# County of Fairfax, Virginia

Re: Interpretation for RZ 2001-BR-022; Fairfax Gateway;  
Tax Map 57-4 ((2)) 24, 26 and 28: Rear Yard and Peripheral Setbacks

RE: Fairfax Gateway  
 Request for Letter of Interpretation (RZ 2001-BR-022)  
 Project #003105.00

**SHEET 3**  
**B**

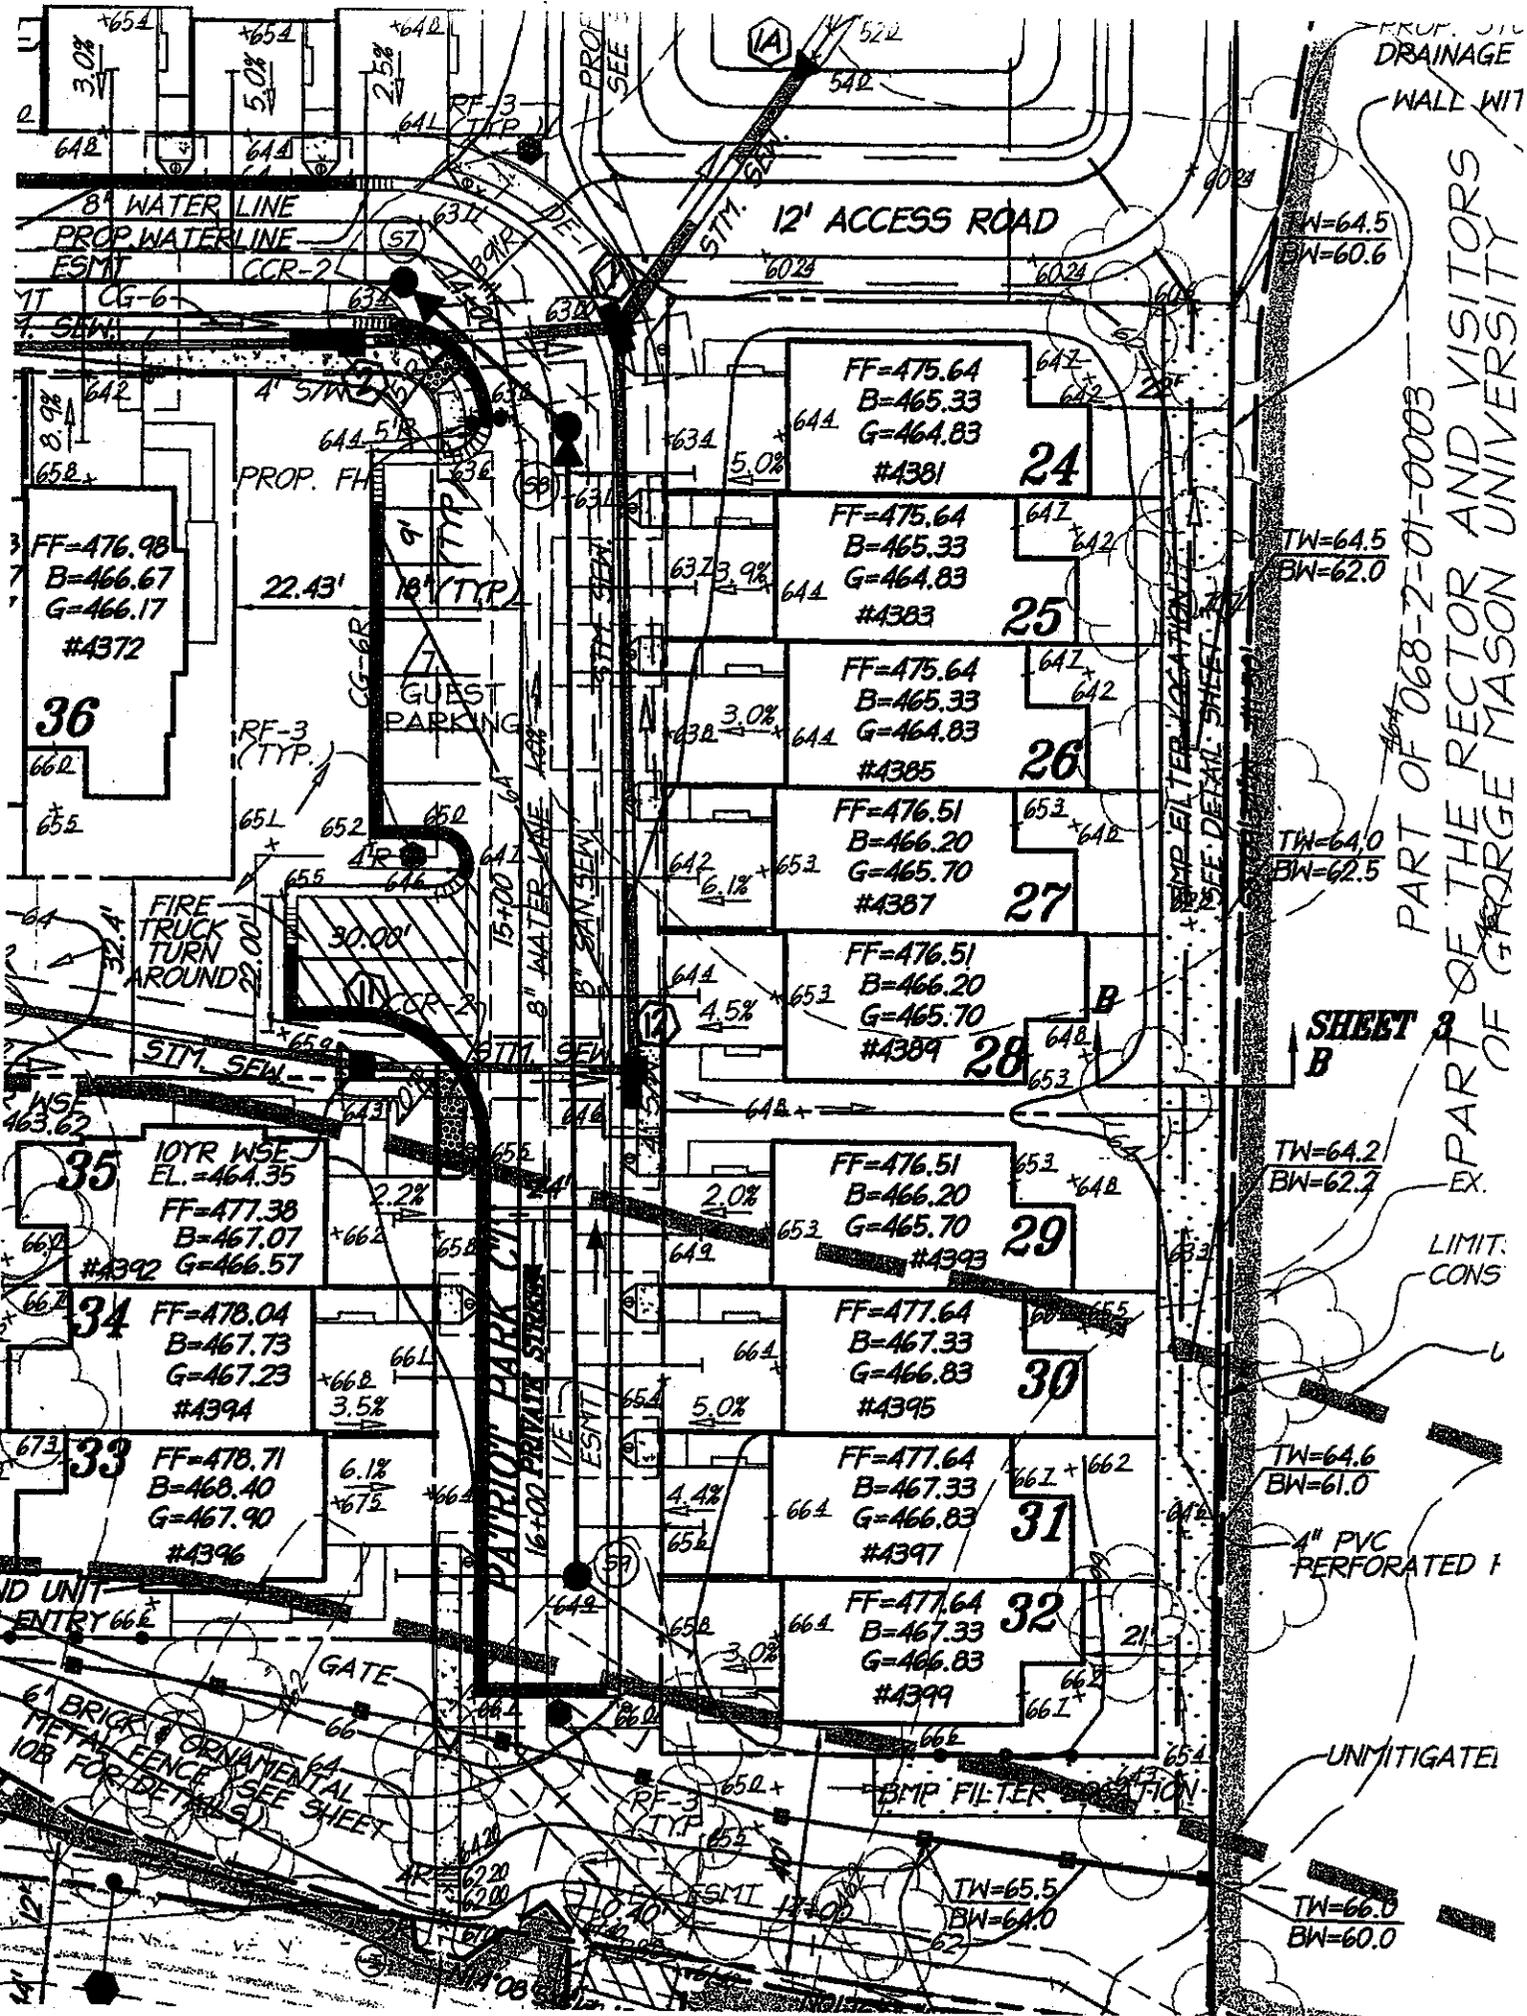
This request is for a determination that the reduction of the rear yards of Lots 24, 26 and 28 from 13 feet +/-, as shown on the CDP/FDP, to 11.3 feet, 11.2 feet and 11.1 feet, respectively, are in substantial conformance with the rear yards shown on the CDP/FDP, including the "Unit Detail, Fairfax County" on Sheet 4 of the CDP/FDP. The previous approval dated November 29, 2006, by the Senior Deputy to the Zoning Administrator, approved the reduction of the rear setbacks on of Lots 24, 26, and 28 to 11.3, 11.2 and 11.1 feet, respectively. The impact of the reduction of the rear yards is a reduction of the peripheral setback as stated in the tables below of 2.2, 1.97 and 2.18 feet, respectively.

It is my determination that the revised rear setbacks and peripheral setbacks on Lots 24, 26 and 28, as stated above, are in substantial conformance with the proffers and the CDP/FDP. This determination has been made in my capacity as the duly authorized agent of the Zoning Administrator.

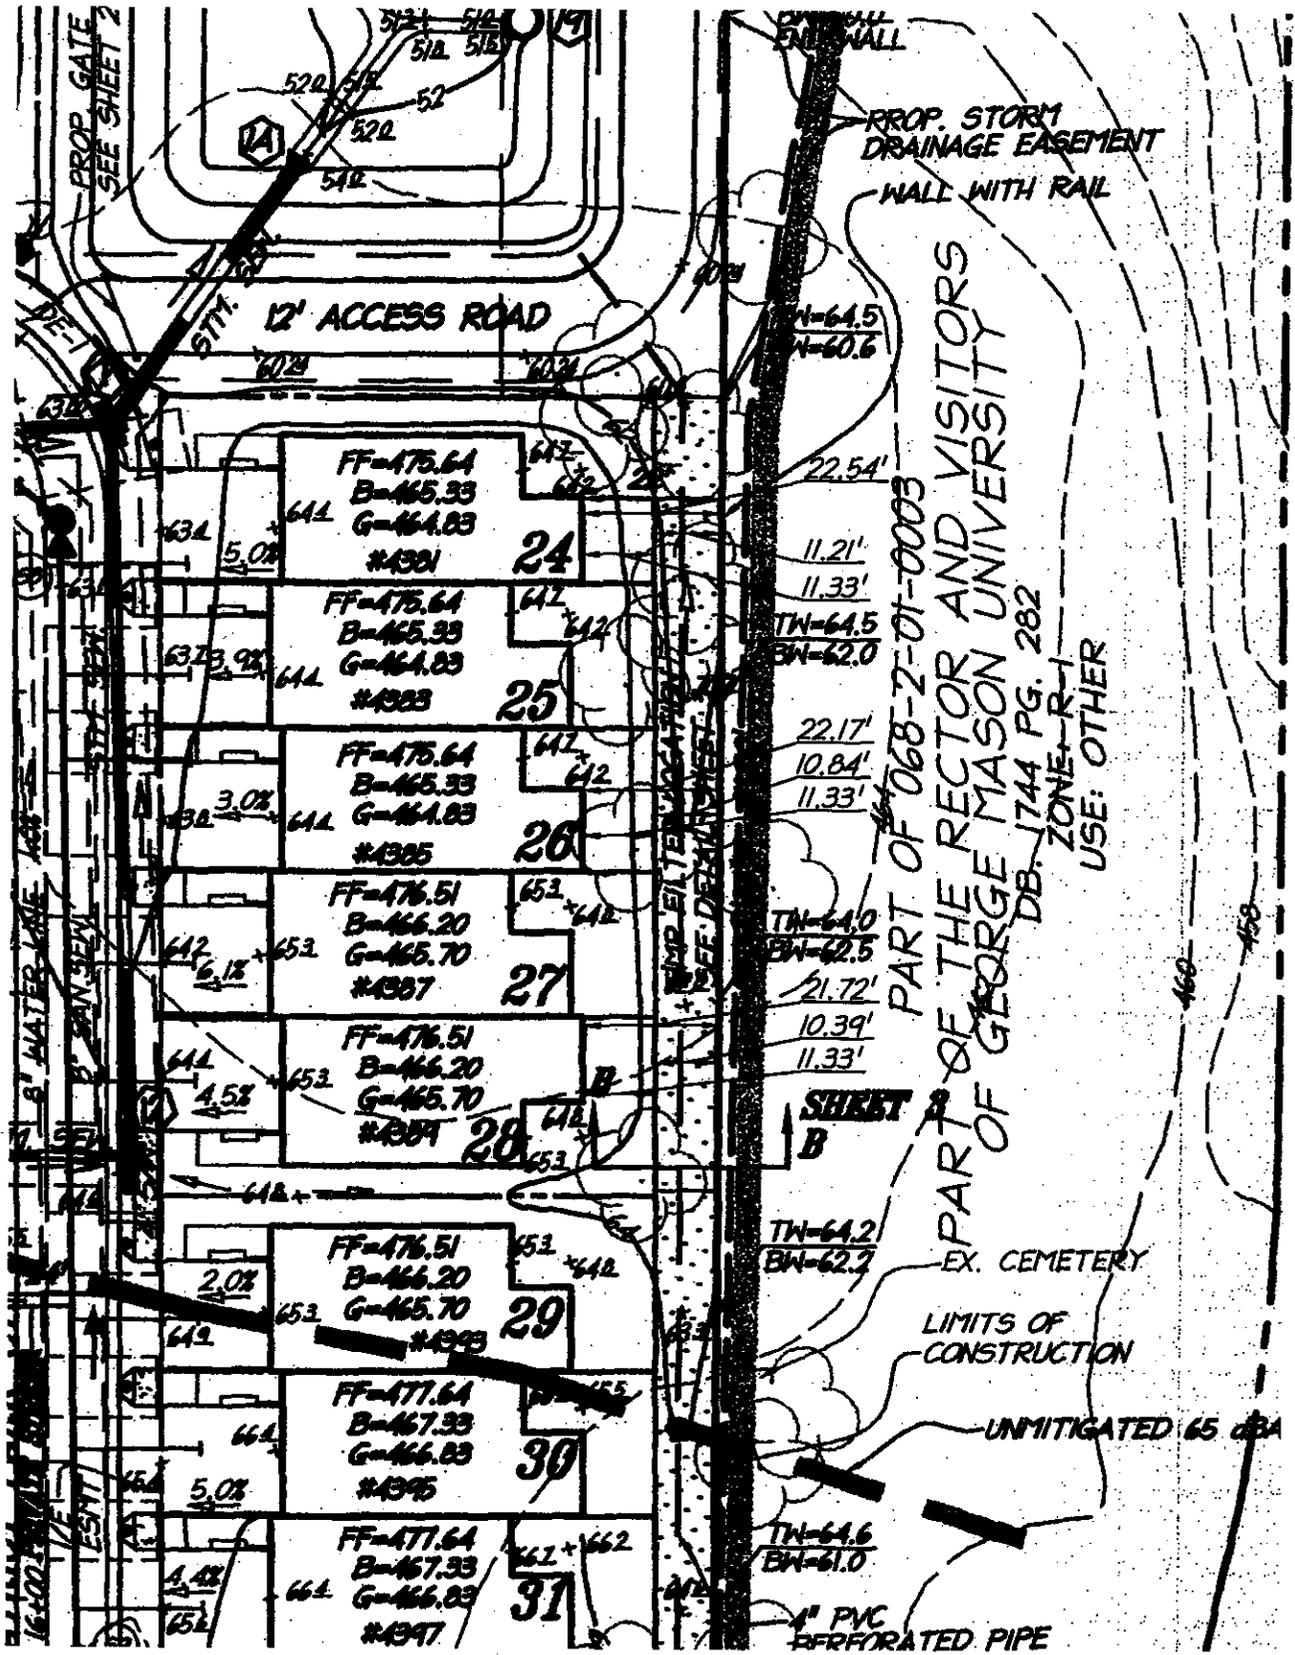
I can't scale the blow up of the 3 subject Lots 24, 26, and 28. What I need are the following dimensions:

- 1) Overall dimension from the townhouse to the peripheral lot line,
- 2) the dimension from the townhouse to the lot line,
- 3) the dimension from the lot line to the peripheral lot line.

The scale of the detail is not standard and therefore I can't get these dimensions. I notice the 3 subject Lots are narrowing the peripheral area a bit more than the Lots 25 and 27. I also notice that those two units do not have the additional sunroom & deck in the back.

Jack,  
I cannot print this document. An area of the three Lots 24, 26 and 28 with the scale would help me.  
Lisa

1. Lot 24 = 22.54'  
Lot 26 = 22.17'  
Lot 28 = 21.72'
2. Lot 24 = 11.33'  
Lot 26 = 11.33'  
Lot 28 = 11.33'
3. Lot 24 = 11.21'  
Lot 26 = 10.84'  
Lot 28 = 10.39'

22.54'  
11.21'  
11.33'  
TH=64.5  
BW=62.0  
22.17'  
10.84'  
11.33'  
TH=64.0  
BW=62.5  
21.72'  
10.39'  
11.33'
